Remarks:

Applicants gratefully acknowledge the Examiner's finding that claims 1-3 would be allowable if rewritten or amended to overcome the rejections under 35 USC 112. Claim 1 has been amended to provide proper antecedent for "the inner transition radius" recited in dependent claim 3. Basis for the amendment appears on page 6 line 19 of the specification. Applicants traverse the indefiniteness rejection against claims 1 and 2.

FIG. 2

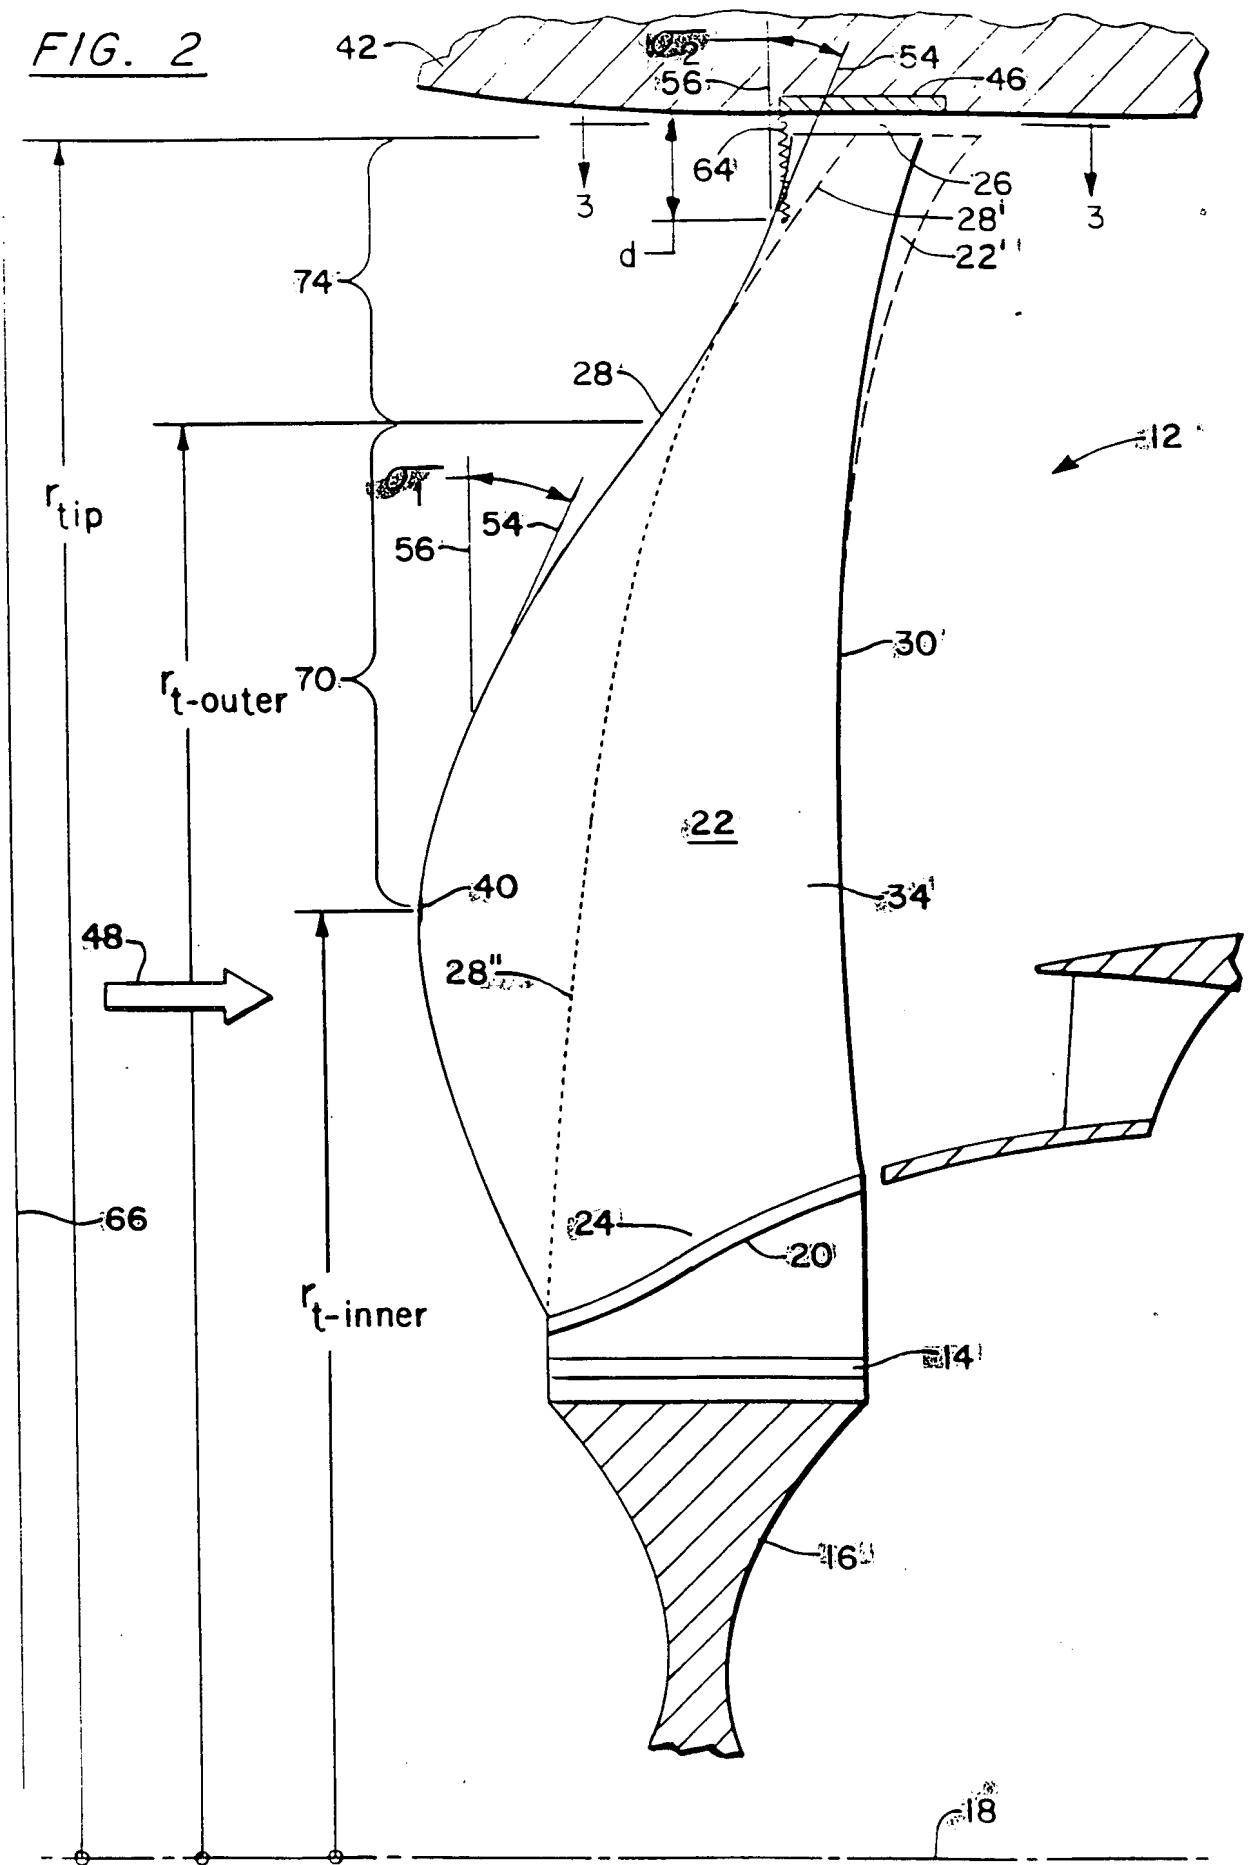
The Examiner has objected to the drawings for failure to include reference sign σ_2 . The Examiner's attention is directed to the enclosed figures 2, 3 and 6 in which the sweep angle σ_2 is highlighted (photocopies of both the informal figures and the corresponding formal figures are included). The illustration of the sweep angle is most meaningful in the side elevations of figures 2 and 6. The sweep angle is shown in Fig. 3 to facilitate the reader's correlation of Fig 3 with Fig 2. The inclusion of σ_2 in Figures 5 and 7 would not improve a reader's understanding of the invention.
